**July 30th, 2024**

**Technical Service Bulletin – 11**

**Safety Harness and Helmet Support Net Collars**

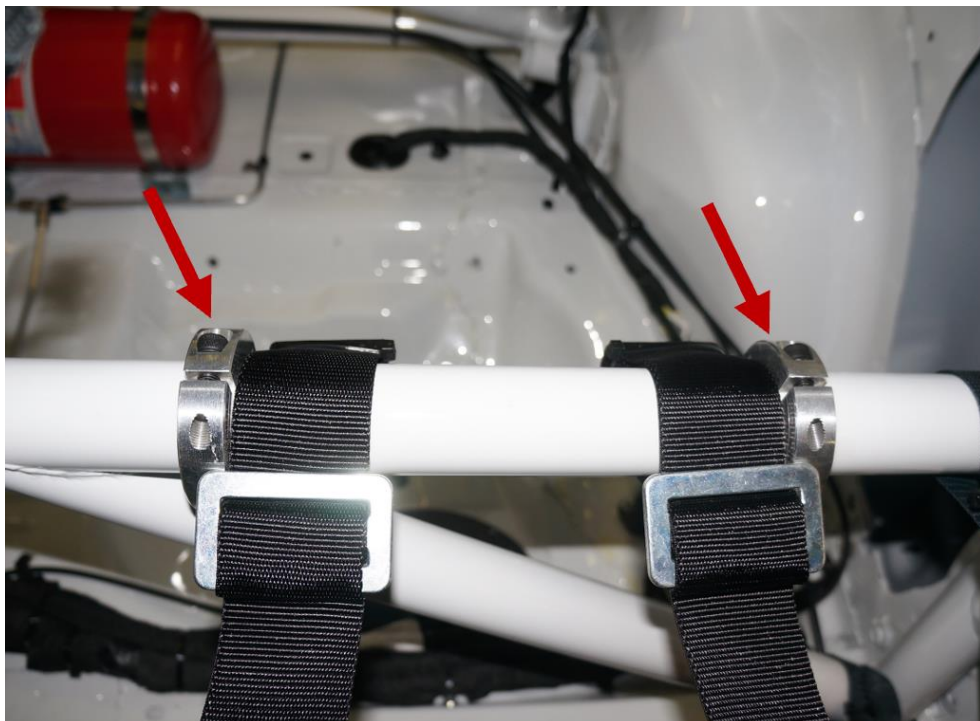
Issue: More robust position control for safety harness and helmet support net webbing is required.

Action: Install collars per photos below.

**4 collars will be provided:**

- Install 2 collars to limit outward safety harness movement on safety cage bar to ensure proper alignment on HANS device

- Install 1 collar on main safety cage hoop as shown to ensure helmet support net is just in contact with seat

- Install 1 collar on main safety cage center area as shown
